Agency Comments

Contra Costa County
Public Works
Department

SUBJECT: **SUBDIVISION SD13-9359/DP13-3035/RZ13-3224/GP13-0003**
"Saranap Village"
STAFF REPORT & CONDITIONS OF APPROVAL
(Hall Equities/Boulevard Way/Walnut Creek/ APNs 184-010-046 & 035, 184-480-025, 185-370-010, 012, 018, 033)

DA 121

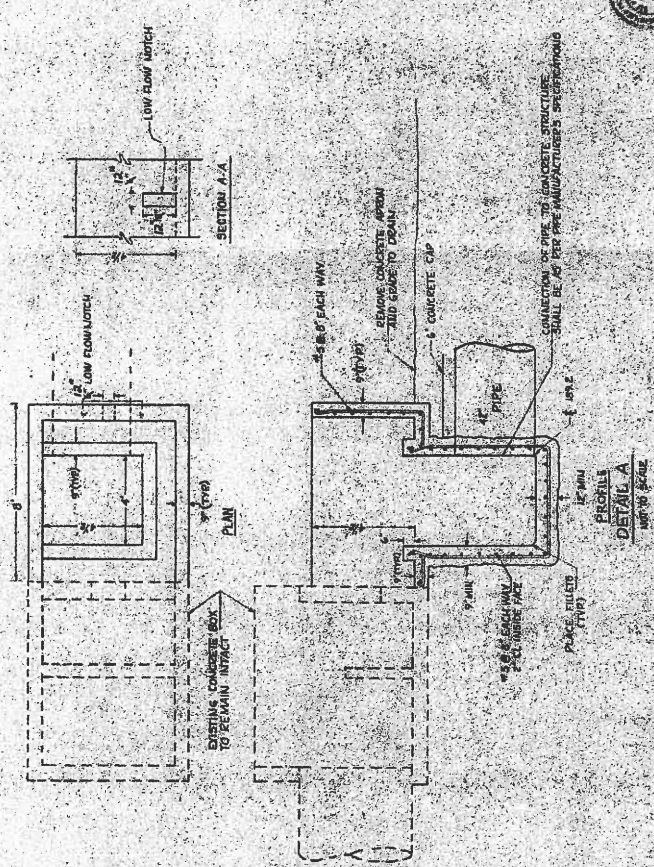
4. We have a history of drainage complaints in the Blade Court/Blade Way area. We recommend that the development prove the adequacy of the existing downstream drainage systems. The drainage improvement at Blade Court that was constructed does not have sufficient capacity to carry 10-year storm runoff. Record Drawing D-12664.2, attached for your use, indicates that it can only accommodate 70% of

Q10 or about 105 cfs. After the construction of the storm drain, there were still complaints in the area of Blade Court about ponding of stormwater and creek bank erosion.

Figure 1: RZ13-3224 & SD139359 Vicinity Map with Alquist-Priolo Zones

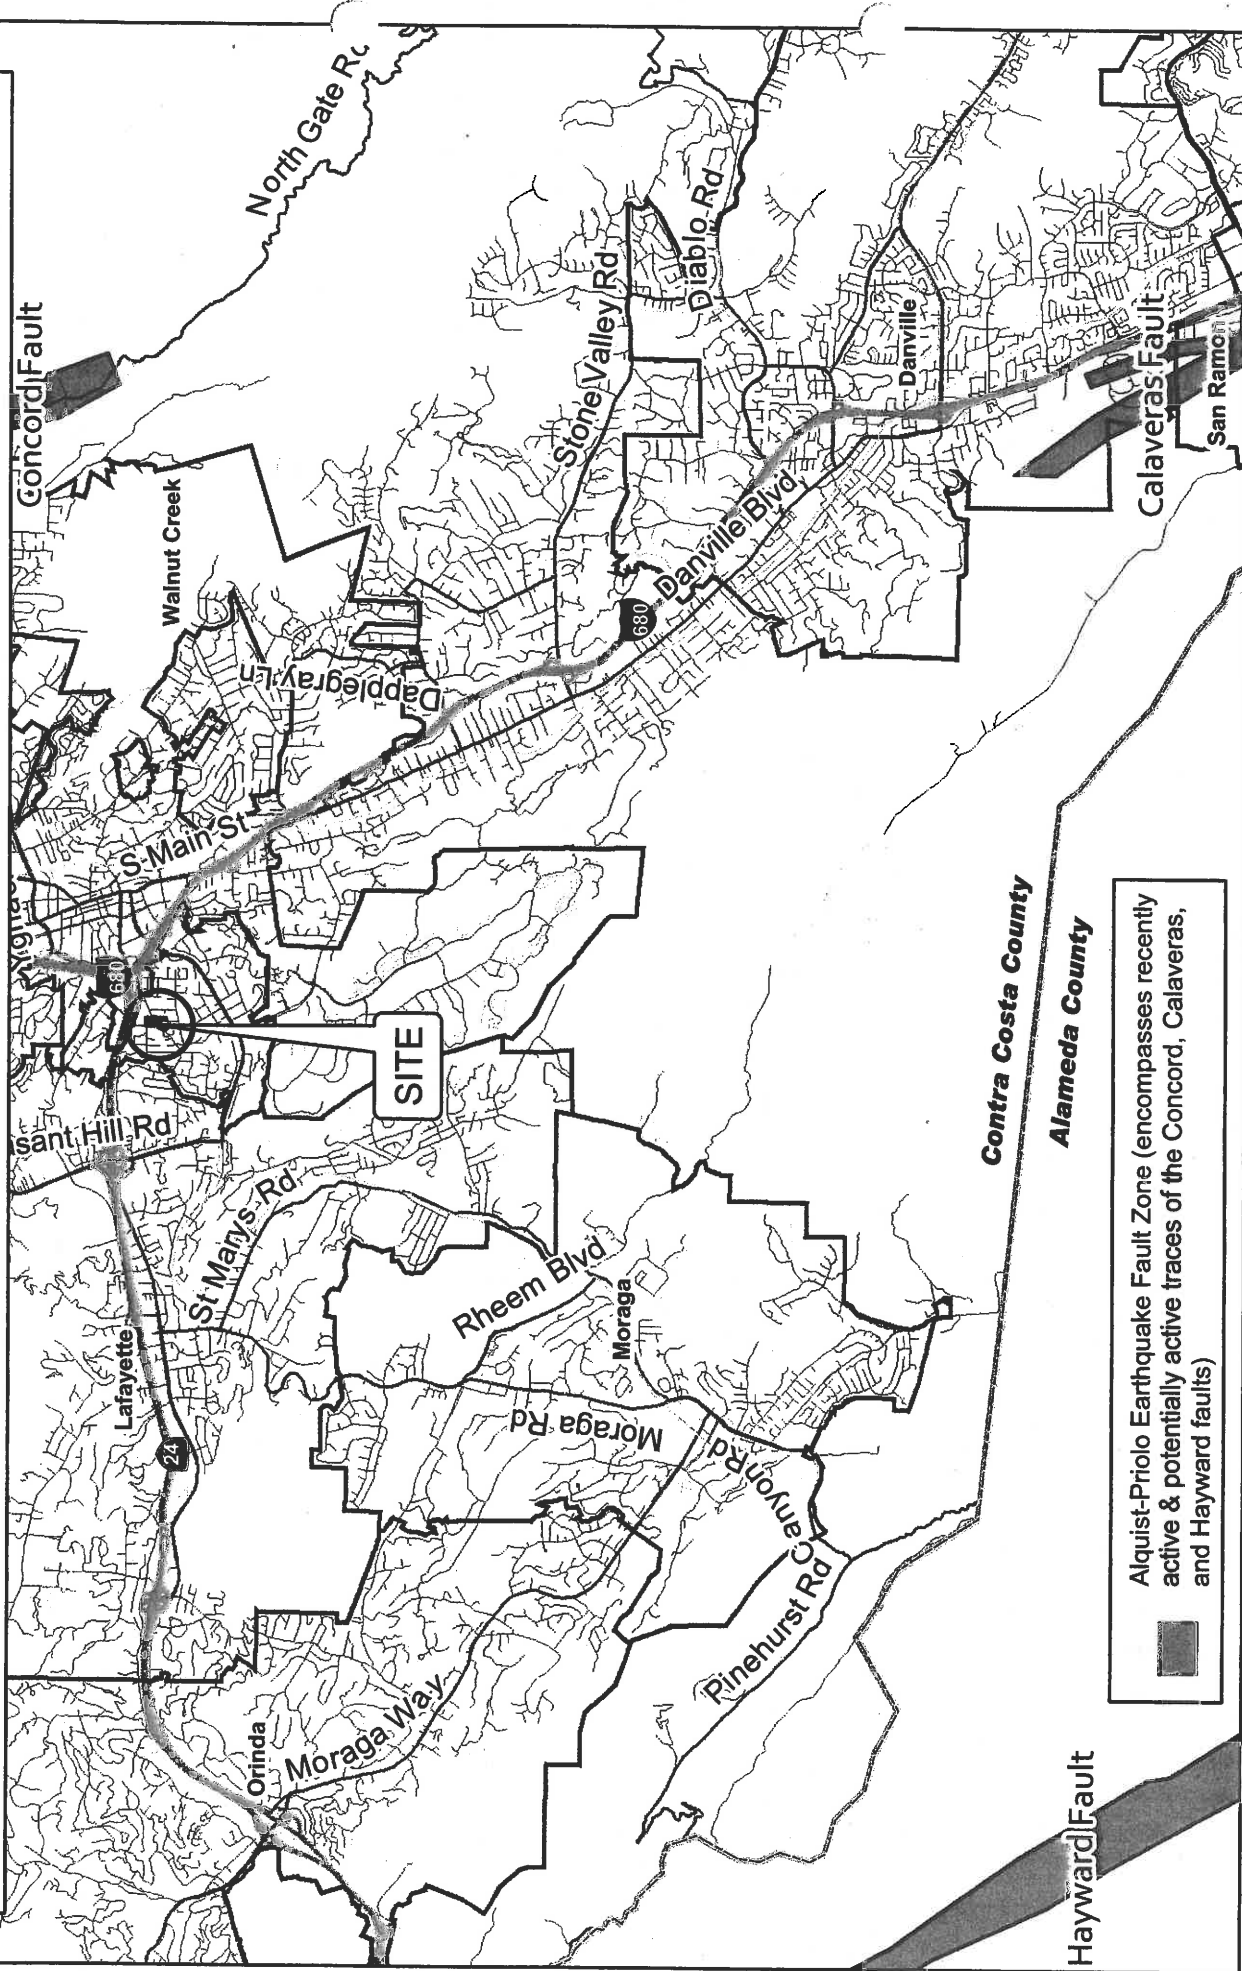
The site is located in the Saranap area, about ½ mile southwest of the State Route 24/ I-680 interchange (see Figure 1). The nearest faults that are considered active by the California Geological Survey (CGS; formerly California Division of Mines & Geology) are the Concord-Green Valley, Calaveras and Hayward faults. The CGS has delineated Alquist-Priolo (A-P) zones along the known active faults in California. The official A-P zones are indicated that the Concord-Green Valley fault A-P zone passes approximately 4½ miles east-northeast of the site. The A-P Zones along the Calaveras and Hayward faults pass approximately 7½ miles southeast and 8½ miles southwest of the site, respectively. (The A-P Zones of these faults are represented by brown-colored, northwest trending zones in Figure 1.) According to the State, recently active and potentially active traces of the active faults may be present anywhere in the A-P Zone. The location of surface rupture generally can be assumed to be along an active major fault trace. Because the subject property is not within the A-P Zone, the probability of the project experiencing surface rupture can be considered very low.

Figure 2: RZ-13-3224 & SD13-9359 USGS Geologic Map

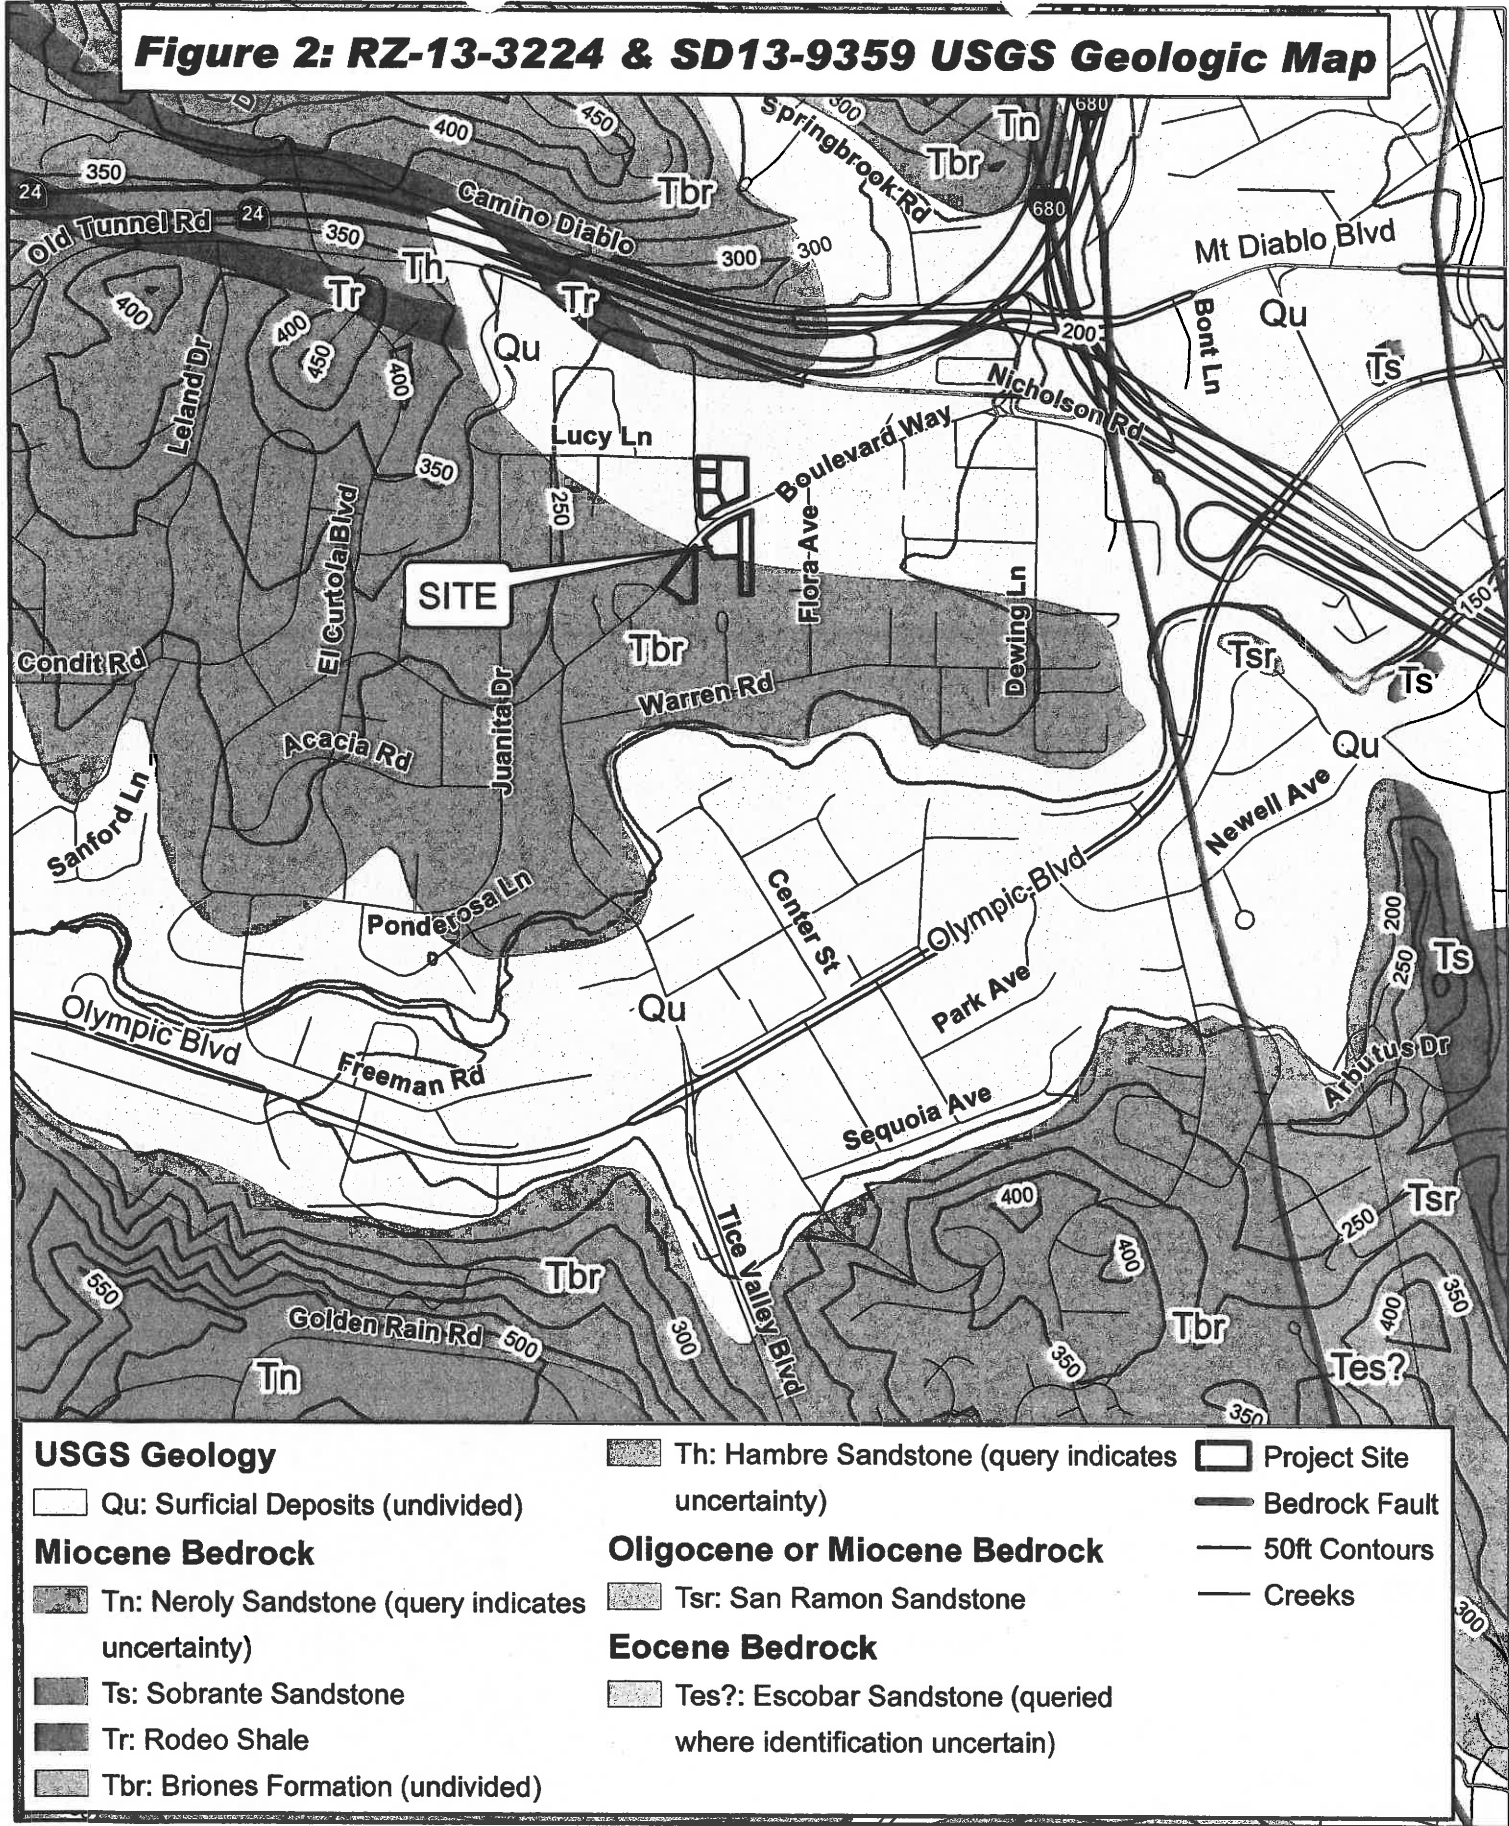
The most recent geologic map of Contra Costa County is a color, digitized bedrock geology map that was published by the U.S. Geological Survey in 1994 (see Figure 2)⁵ This map, which is based on the compilation of previous published mapping, indicates the site is located in the outcrop belt of the Briones

Formation (Tbr). Note that the seven parcels that make up the property are outlined in red. Tbr is a formation consisting of marine sedimentary rocks of Miocene age (chiefly interbedded sandstone, siltstone, conglomerate). According to Figure 2, the northern half of the subject property is mantled by surficial deposits (Qu).

Figure 3: RZ13-3224 & SD13-9359 USGS Quaternary Map

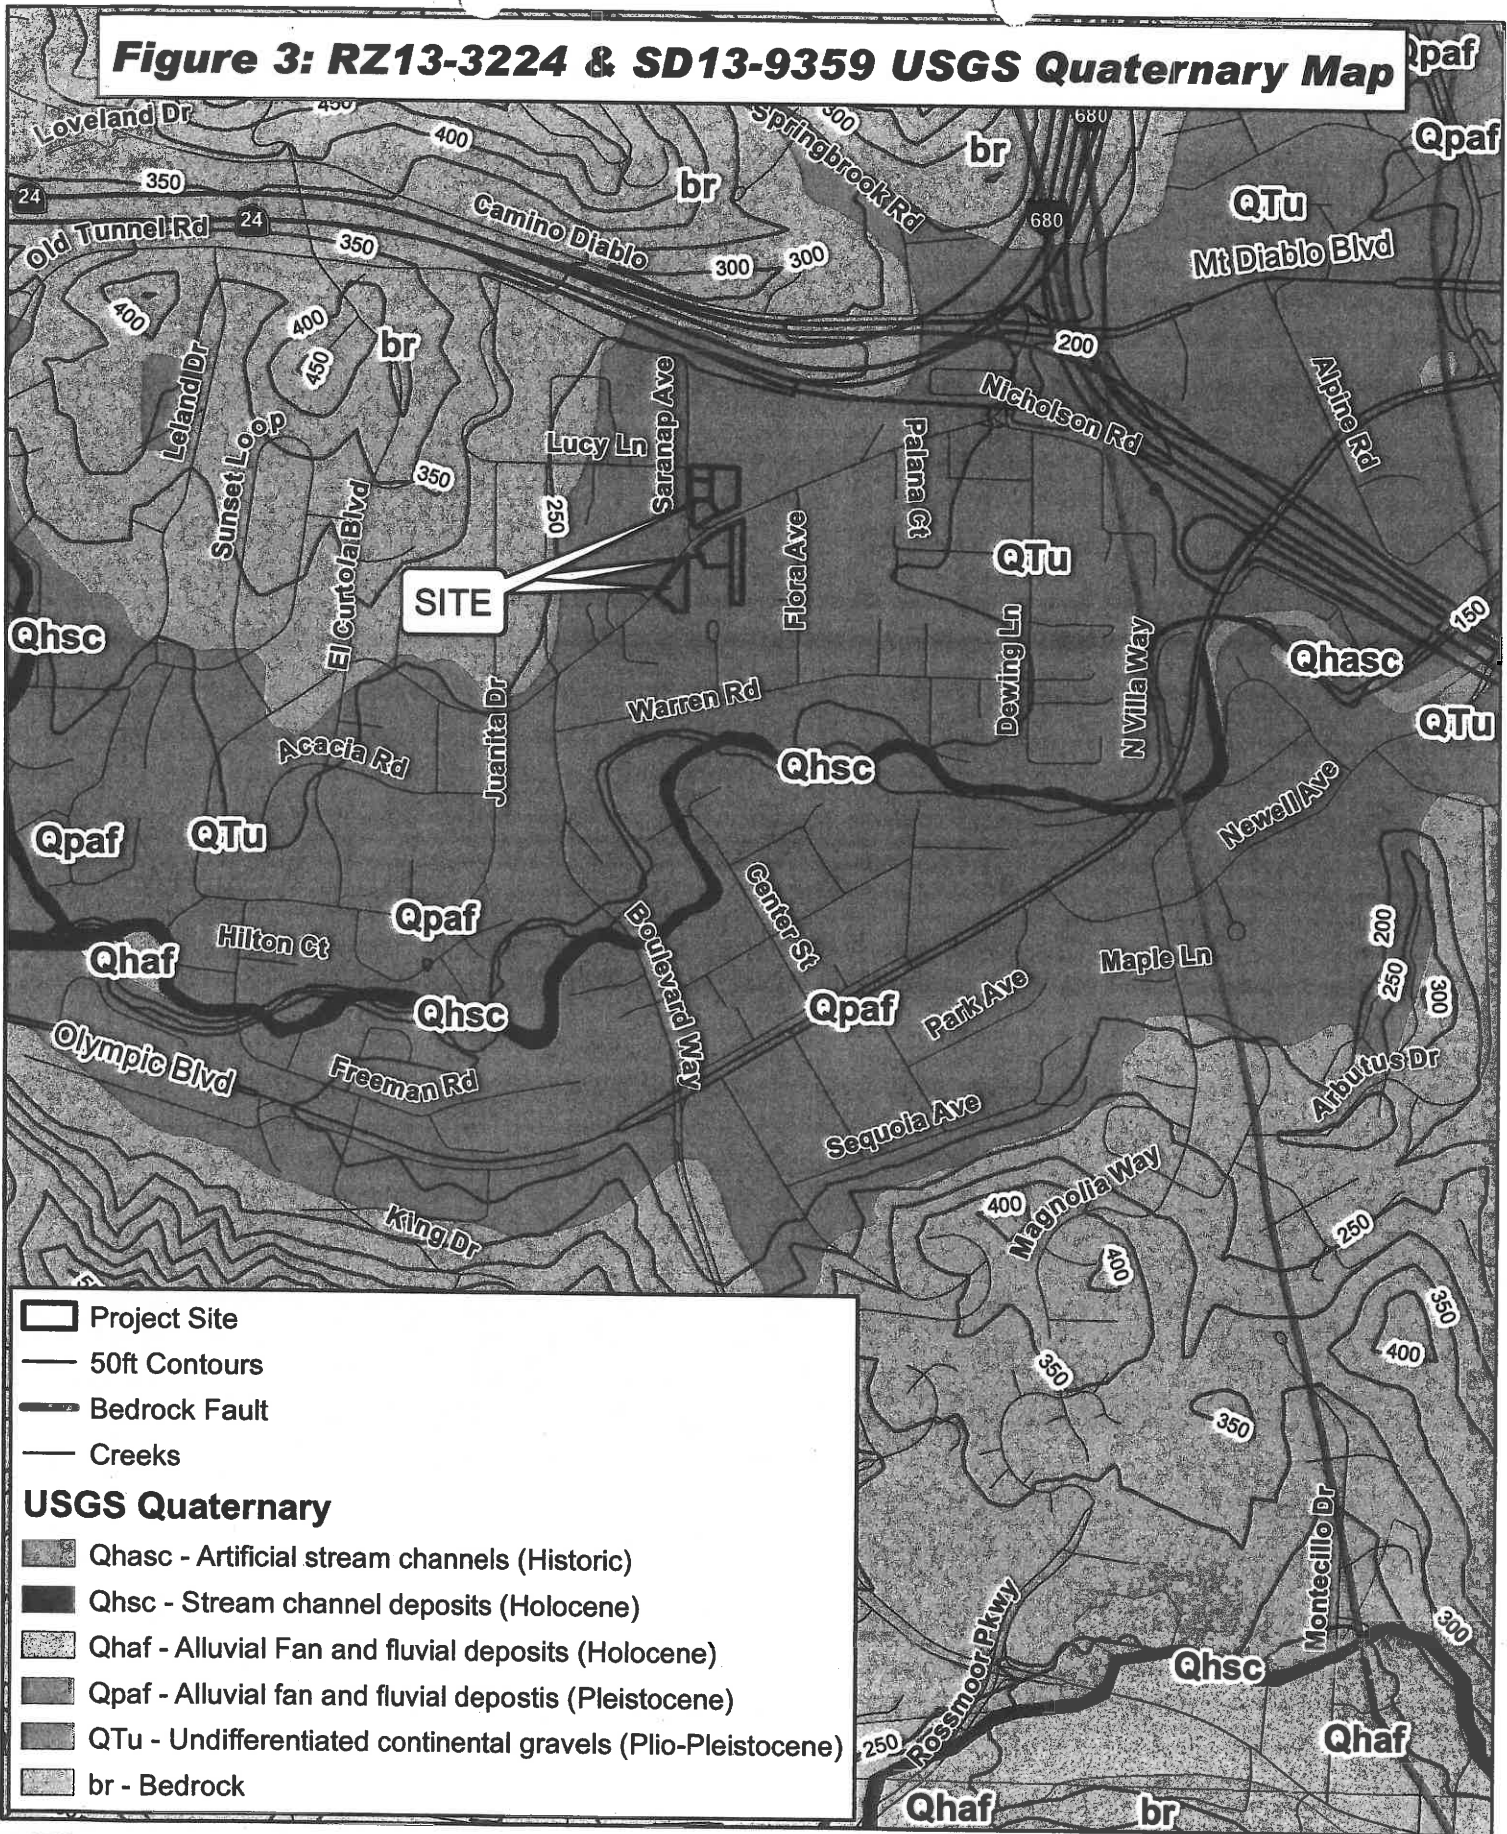
In 1997 the U.S. Geological Survey issued a map that divided Quaternary deposits of Contra Costa County into nine categories that vary in age, depositional environment and engineering properties.⁶ Figure 3 presents a portion of this map, showing the site and vicinity. It indicates that the subject property is underlain by “undifferentiated continental gravels” (QTu), of Plio-Pleistocene age. They are described as semi-consolidated to unconsolidated and poorly sorted. The sediments consist of irregularly interbedded gravel, sand, silt and clay. The USGS report states that these deposits are (a) unrelated to modern drainages, (b) their thickness is variable but locally ranges up to 50 meters, and (c) these deposits are considered evidence of the late Cenozoic uplift of the Coast Ranges. Other surficial deposits shown on Figure 3 are all younger in age than QTu. They include the following:

- Alluvial fan and fluvial deposits (Qpaf). These deposits are of Pleistocene age, and consist of dense, gravelly and clayey sand or clayey gravel that fine upward. These deposits are mapped chiefly south of the Las Trampas Creek channel (see Figure 3).
- Stream channel deposits (Qhaf). These are deposits of Holocene age (<13,000 years before present), and consist of stream channel deposits of Las Trampas Creek.
- Alluvial fan deposits (Qhaf). These deposits are of Holocene age and tend to be brown to tan and medium dense (never reddish).
- br. This symbol denotes the rocky upland areas that overlie the valley floor area.
